Technical Memorandum

Review of Underground Injection Control Permit and Application Gunnison Copper Project

January 6, 2017

Draoon, Arizona

Figure 2: Figure 5-10 from Clear Creek Associates (2016) showing the potentiometric surface at the site and to the west and northwest.

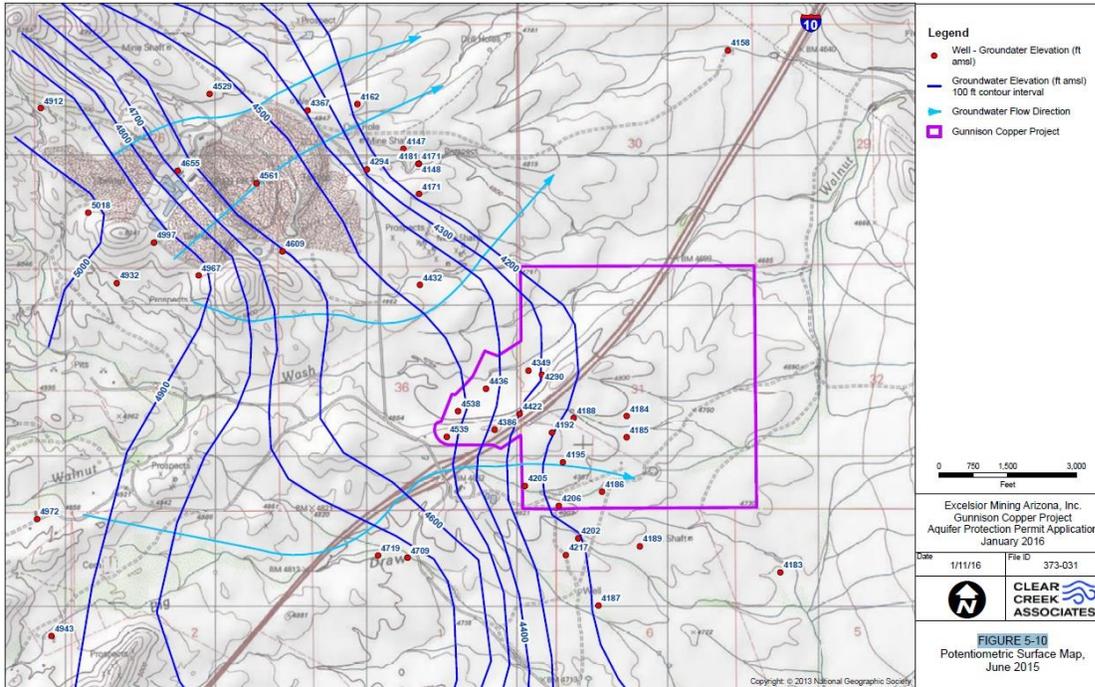
would miss the project site by a mile or more. The potentiometric surface (Figure 2) appears to drop steeply northeast of the mine and appears to form a ridge on the west side of the project site.

- Due to the importance of understanding the source of petroleum products, Excelsior should reconsider the potentiometric surface map to consider whether the water levels used for mapping all represent the same aquifer level. In a fractured rock aquifer, it is not often appropriate to assume there are no vertical gradients. The map with water level with respect to the top of the bedrock (Figure 5-12, CCA 2016a) shows significant variability in small areas, suggesting that it is possible the water levels represent different bedrock levels. It is possible that groundwater flows southeast from the mine at certain levels. For this reason, the mine cannot be ruled out as a source.
- Hydrocarbons in the groundwater could affect the chemistry of the project. Excelsior must complete a larger survey of the LNAPL contamination and assess whether and how it could affect ISL operations.

Figure 4: Figure 123 from CCA (2016) Attachment A-3 showing the relation of hydraulic conductivity with azimuth between pumping and observation wells.

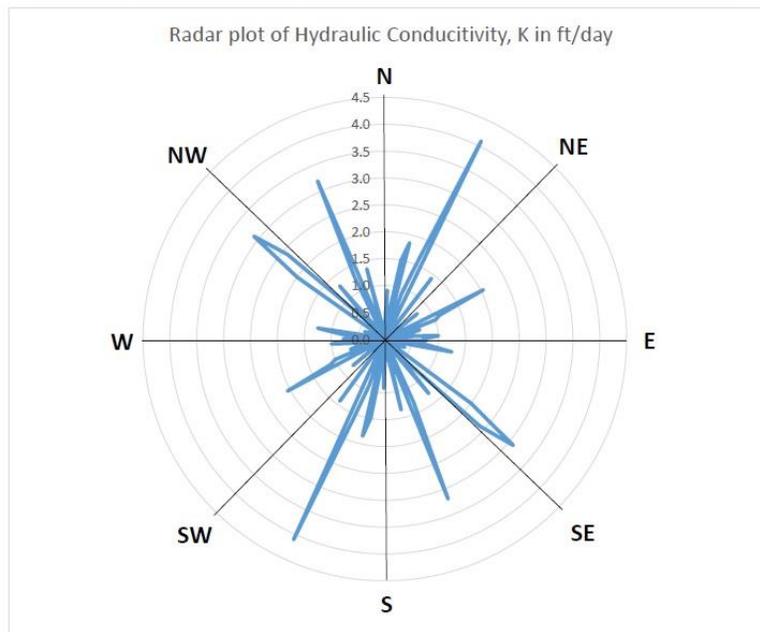
Attachment A-3 presents a directional plot of conductivity with azimuth (Figure 4). Rather than showing “that the hydraulic conductivities are relatively evenly distributed with little prevalent direction” (Attachment A-3, p 31), Figure 4 shows a substantial correlation with direction. This is especially true for a direction from midway between north and northeast and between south and southwest, where the K exceed 4.0 ft/d, and for a roughly perpendicular direction along which K is just over 3.0 ft/d. Additionally, between those transverse K trends, there is another line of about 3.2 ft/d trending from between north and northwest to between south and southeast. K in other directions is less than half as much. The trends show a perpendicular fracture pattern, but do not demonstrate that “the fracture patterns intersect sufficiently at the well spacing of 100 feet to smooth out, for the purpose of hydraulics, discrete fracture spacing which is on the order of one foot” (Attachment A-3, p 31). There is nothing in the Appendix, or anywhere in the Application, that indicates the spacing of the intersection of fracture patterns or of one-foot discrete fracture spacing.

The property data identified in Attachment A-3 was used “to populate and calibrate the hydrogeological flow model” (Attachment A-3, p 32), but they ignore heterogeneity and directional tendencies.

- Excelsior should consider horizontal anisotropy in its modeling and project design. The effects of not considering this are better considered below in the discussion of modeling.

Figure 5: Figure 5-9 from Clear Creek Associates (2017a) showing the wells and coreholes with petroleum hydrocarbon hits.

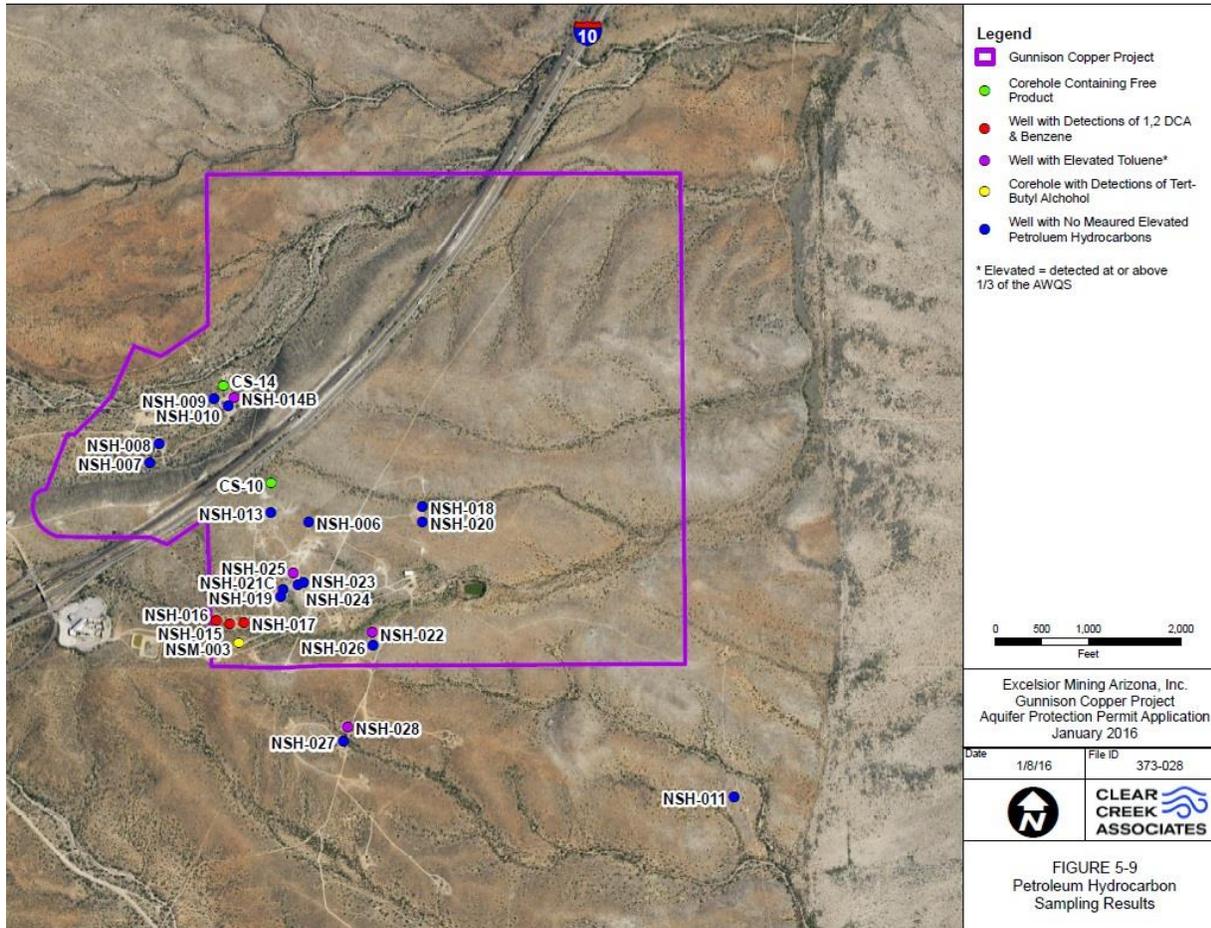
Excelsior reported petroleum products in the groundwater on the project site. The following discussion of petroleum contamination is based on the discussion in the UIC application (CCA 2016), because no discussion of petroleum contamination was found in the UIC documents. Coreholes CS-10 and CS-14 had free petroleum product in the groundwater, which means there is LNAPL (light, non-aqueous phase liquid) floating on the surface of the water (Figure 5). After pumping it from the corehole, it reappeared and was 0.25 feet thick in about ten days (CCA 2016, p 5-8). That indicates there is a significant source of LNAPL near the site. The clustering of wells with different hydrocarbons, as seen by the distribution of hydrocarbons in Figure 5, may reflect different transport and attenuation rates for the different products within the fracture zone affected by the source. The intermixed wells without any hits may be screened in different fracture zones.

Excelsior explains the potential sources are The Thing gas station and the Johnson Camp Mine, although the mine may not have stored petroleum products (CCA 2016, p 5-9). The Thing site had underground storage tanks removed in 1996 because there had been contamination detected in the soil. ADEQ closed the case files investigating the contamination between the substantial depth to groundwater (hundreds of feet) and the presence of bedrock just two feet below the tanks. Most of the detections (Figure 5) are potentially downgradient of the Thing site (Figure 2). If indeed The Thing is the source, there has been substantial transport and lack of attenuation, which could be a significant source of contamination to the project.

As noted, the mine apparently did not use gasoline, so Excelsior seems convinced that it could not be a source (CCA 2016, p 5-9). They also point to the gradients of the potentiometric surface which suggest that groundwater flow from the mine would be to the northeast and

Figure 7: Figure A-7 from the draft permit, Appendix A, showing the project area and location of hydraulic control wells, observation wells, and point-of-compliance wells.

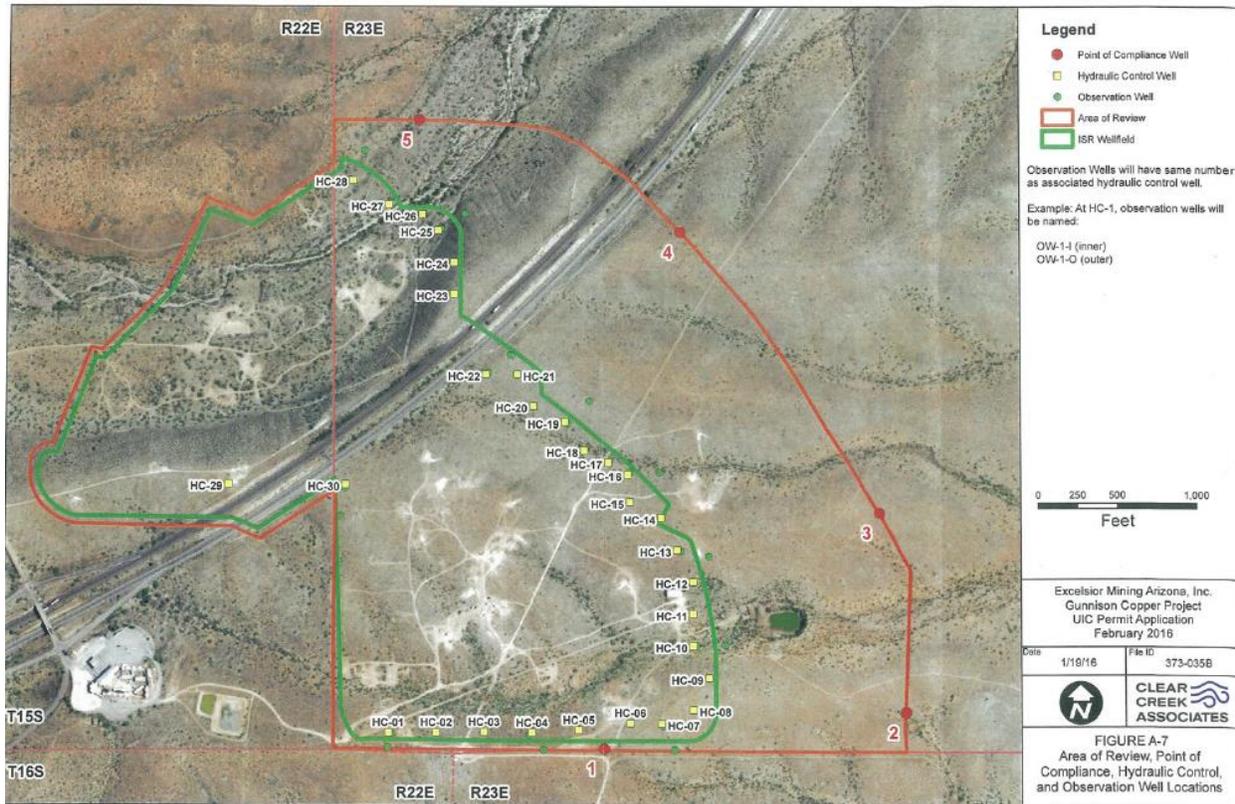
Figure 7, Figure A-7 from the draft permit, shows the HC, IMW, and POC wells for the site. The OW wells show as green circles without labeling; some of them plot underneath the yellow squares showing HC wells, so the figure is not perfectly clear. There are three pairs of OW wells and seven HC wells across the southern boundary of the well field, or about 2000 feet. Most remaining HC wells spread along the east and northeast boundary of the site, about 4000 feet, with two HC wells on the west. There are seven pairs of OW wells on the east and one pair on the west (Figure 7). Not all wells would operate simultaneously, however. Draft permit, Appendix A, Figures A-7a, A-8, and A-13 through A-16, show the monitoring wells as operated for given time periods. The draft permit does not show the monitoring well layout after year 13 (Figure A-16), which is the end of mining stage 2. This is a concern because it is after year 13 that mining stage 3 begins, during which most of the project area is being mined at the same time. With over 25,000 gpm being injected, this would seem to be the most important time period for extensive monitoring.

HW and OW wells surround the immediate project site, as shown in Figure 7. HC wells would surround the project site and are pumped to create a trough in the water table to capture any water escaping the project and to assure that flow is toward the project. There would be up to 30 such wells, although not all would operate at the same time, with operations based on which sections of the project are being processed at any given time. The amount of water pumped from them would cause total project recovery to exceed total injection by 1%. Fluids pumped from the HC wells would be monitored for SC, so if these wells capture any project lixiviant, SC would spike. Twenty-two paired OW wells (11 pairs) would monitor the gradient, which is intended to be inward, with inward meaning that groundwater levels outside the project would exceed those inside the project. The OW well pairs must demonstrate a 1% gradient toward the well field.

Second, five wells spaced along the perimeter (Figure 7) is grossly insufficient spacing. Large contaminant plumes could flow between the wells undetected.

- The number and spacing of POC wells should be determined by modeling of contaminants being released either within the well field or the ponds accounting for horizontal dispersion. Well-spacing should be less than the width of simulated plumes at the line of POC wells.
- The POC wells downgradient from the well field should monitor different vertical preferential flow paths separately. That means that at each POC well location, the wells should monitor each potential flow zone. Either nested wells or multiple opening wells could be used. Multiple screened openings along the bore hole no more than 20 feet long would be preferable so that the depth of the contaminant could be determined.

Figure 8: Portion of Draft Permit, Appendix A, Figure A-13 showing the intermediate and HC monitoring well layout for year 1. the green circles are IMW wells, the triangles are inactive HC wells. The figure shows faults and the project boundary (blue dashed line).

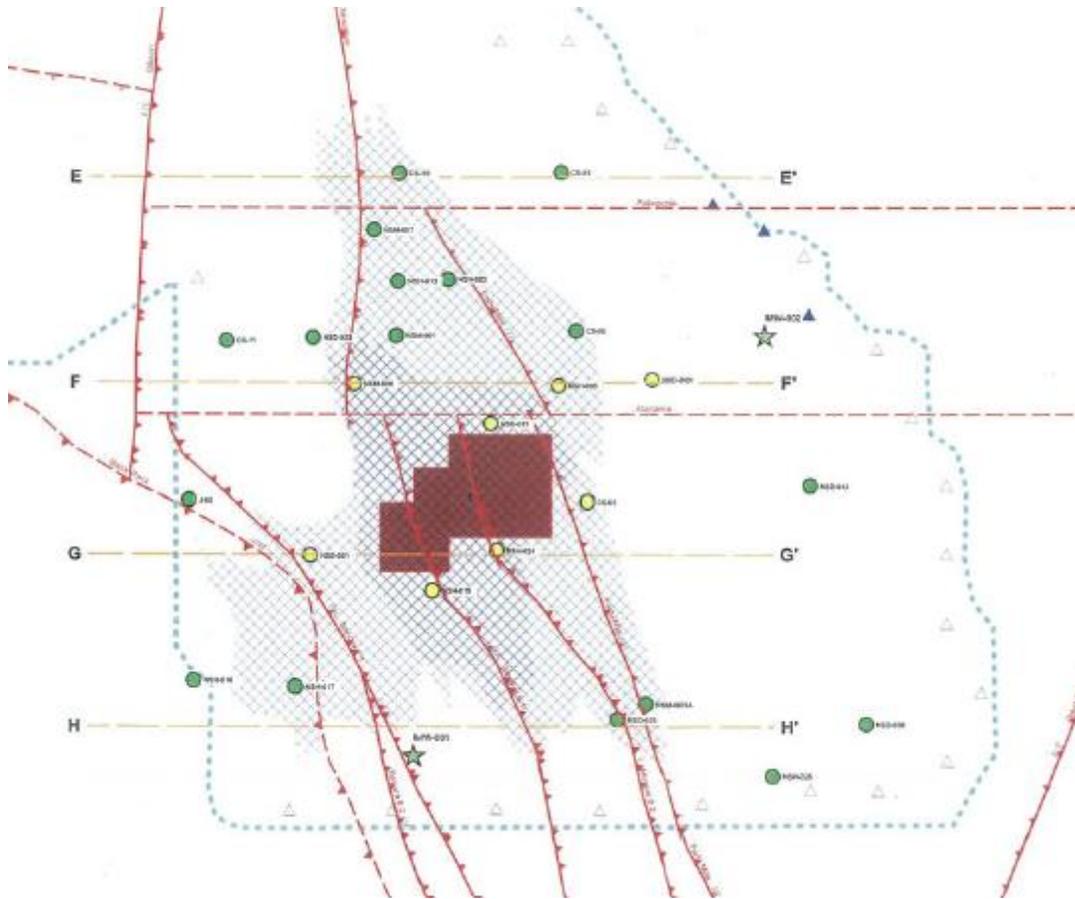
The Draft Permit establishes special consideration for three HC wells established on the southern project boundary prior to year 1 (Draft Permit, p 25). The consideration includes daily monitoring of SC, even though the development is at least 700 feet north of the boundary. This indicates the EPA recognizes the potential for southward flow, but their response is inadequate because the wells would be spaced too widely. Figure A-13 shows the wells fields and IMW wells at year 1 (partially reproduced here as Figure 8), including at least six faults trending NW-SE. Any of these faults could provide a pathway for contaminants to escape the project site, especially with a pressure boost from injection. The monitoring of this potential threat is grossly insufficient.

- The HC wells should be fully installed and active at the beginning of mining. This would create a trough in the water table that would prevent excursions, if the pathways are connected to the regional water table.
- HC wells should be installed in fracture zones associated with the faults.
- The faults should be more fully monitored, with IMW wells situated along each of them.
- POC wells on the south boundary should be outside the boundary created by the HC wells. This is necessary to monitor for contaminants not captured by the HC wells. The POC wells should be about 300 feet south of the HC wells, and be associated with fractures and pathways associated with the faults.

Figure 9: Figure 19 from CCA (2016) Attachment A-2 showing the groundwater model grid.

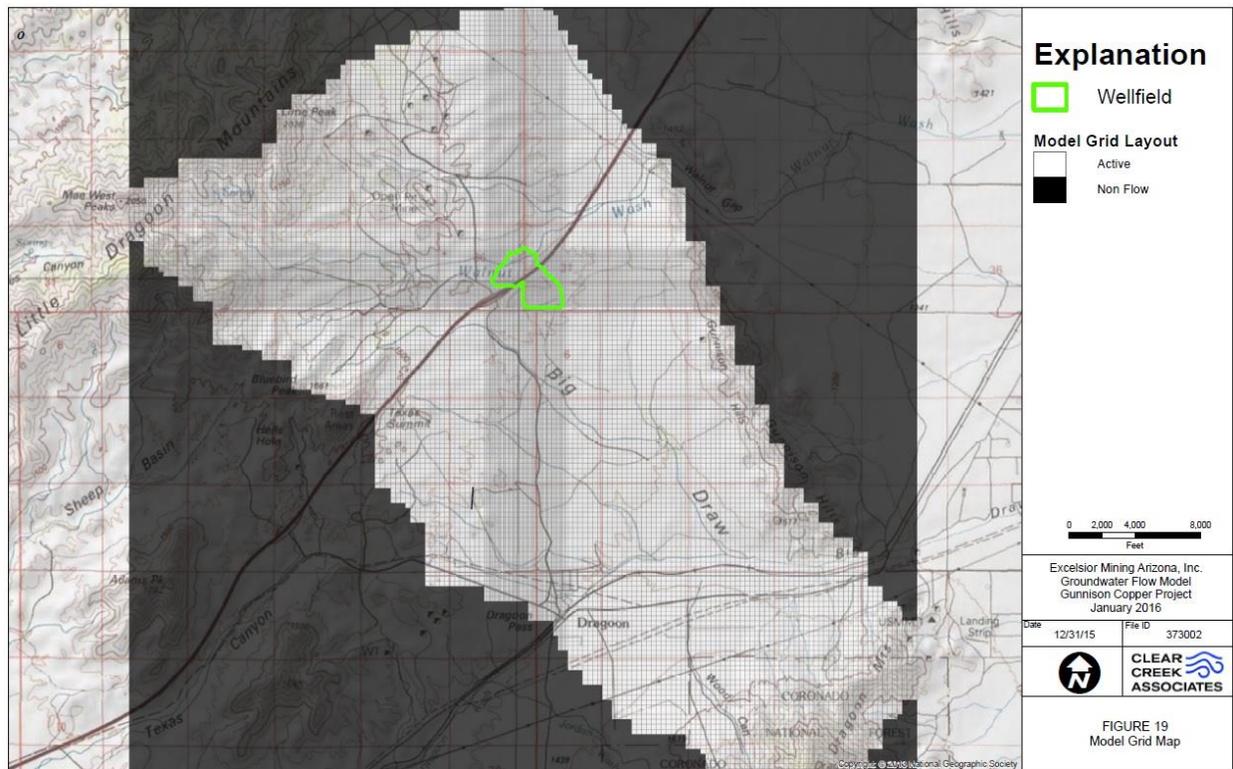
Solving the equations completes a water balance among model cells that describe parts of the domain. For this site, the cells range from 300 feet to 75 feet square, with the finest discretization in the well field (Figure 9), which allows for more detailed calculations. The model domain extends from the Little Dragoon Mountains in the northwest to the Dragoon Mountains in the southeast (Figure 9).

Figure 10: Figure 18 from CCA (2016) showing the model layers and geologic formations dipping east through them.

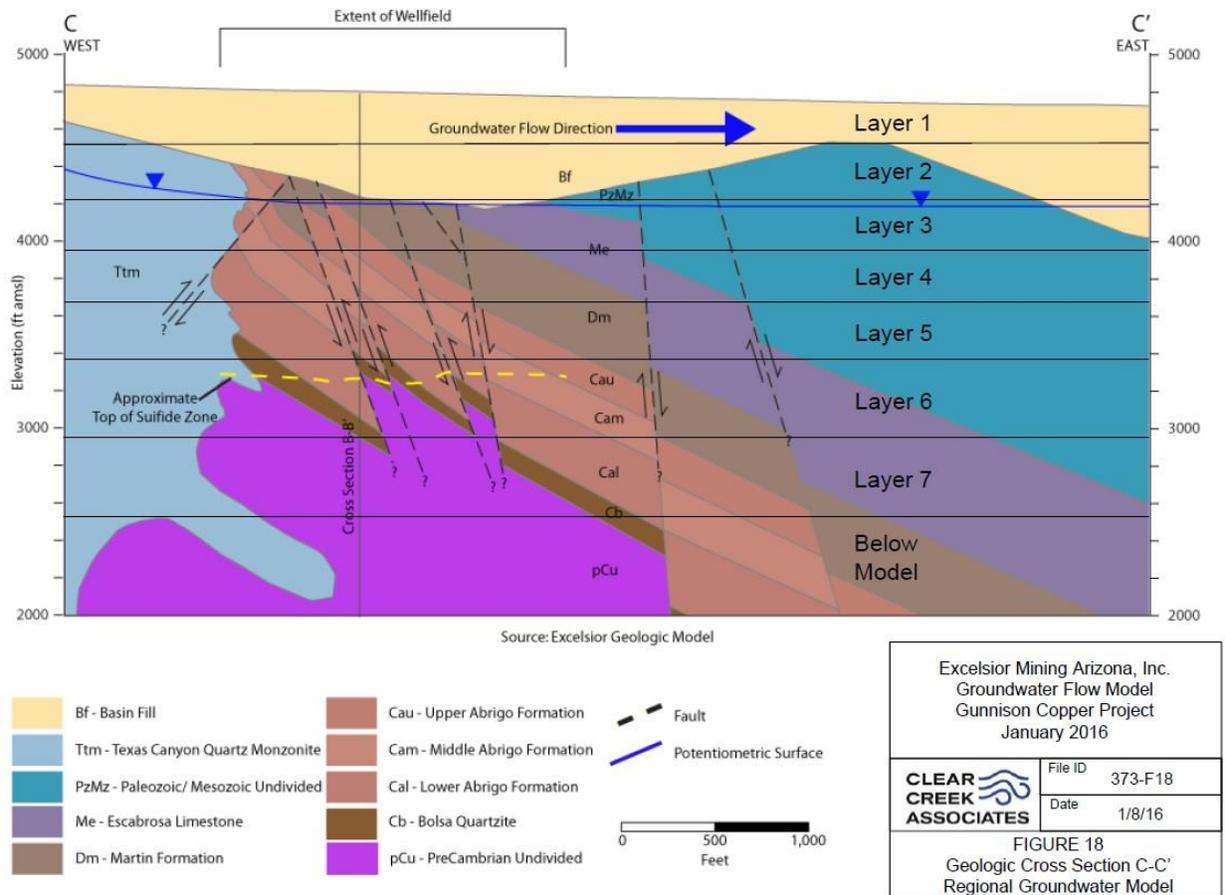
Vertically, the geologic formations are divided into seven layers. Layer 1 varies from 85 to 1648 feet thick, while layers 2 through 5 are 300 feet thick, and layers 6 and 7 are 400 feet thick (Figure 10). All layers are bedrock in the west where bedrock outcrops in mountains and layer 1 is basin fill everywhere other than at the outcrops (p 18). Layers 2 through 4 have decreasing amounts of saturated alluvium corresponding with the deep fill east of the project. The lower portion of all layers is horizontal, meaning that formations dip through the layers (Figure 10). Layer 1 is unconfined, layers 4 through 7 are confined, and layers 2 and 3 are convertible, meaning the model would treat them as either aquifer type depending on the simulated water

level. The layers are much too thick to accurately simulate the flow around the injection/collection wells which would depend on fracture zones.

Figure 12: Magnified portion of Attachment A-2, Figure 22 showing the details of the parameter zones on the west side of the ore body, and to its south.

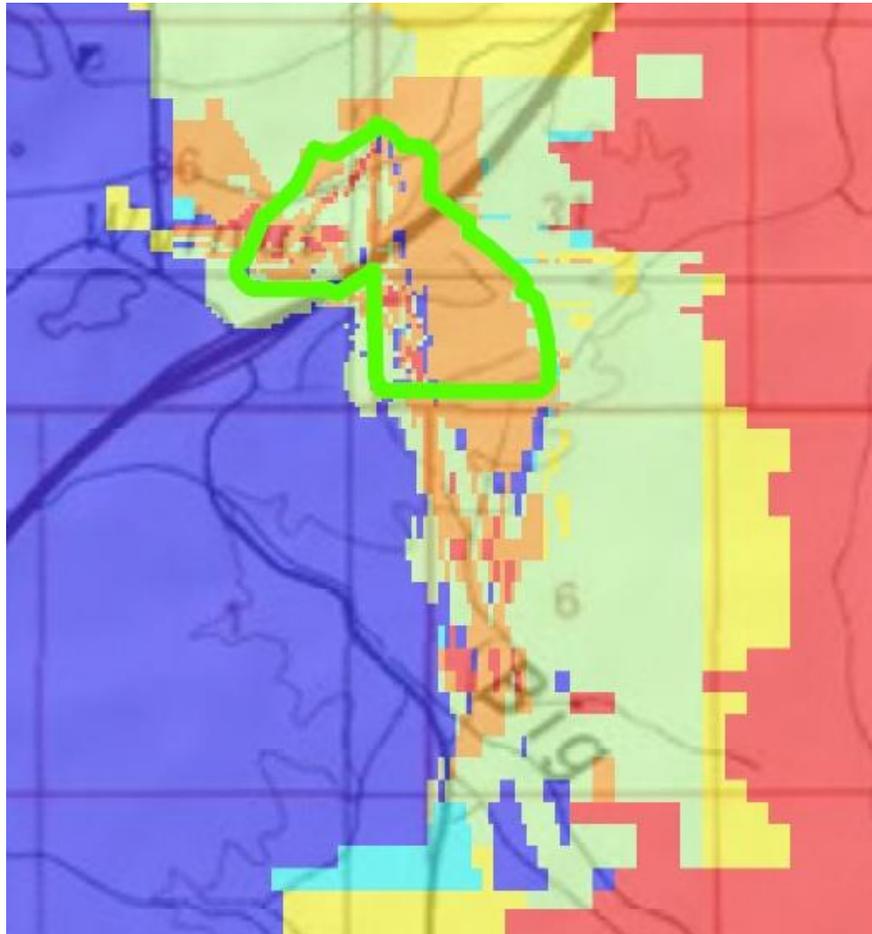
Because of the fracture intensity modeling, the model has very detailed parameter zone models within the ore bodies, as can be seen from detailed observation of the ore body on the parameter zone maps for each model layer (App I, Figures 21 -27). Most of the well field area has K equal to 0.5 to 1.0 ft/d, with some intermittent higher and lower cells that resulted from

the detailed fracture intensity modeling. The west half of the ore body has the most detailed parameter zones, as may be seen in the magnified portion of App I Figure 22 shown in Figure 12 for layer 2. The complicated fracture intensity model may represent the fractures associated with faulting, as shown in Figure 11.
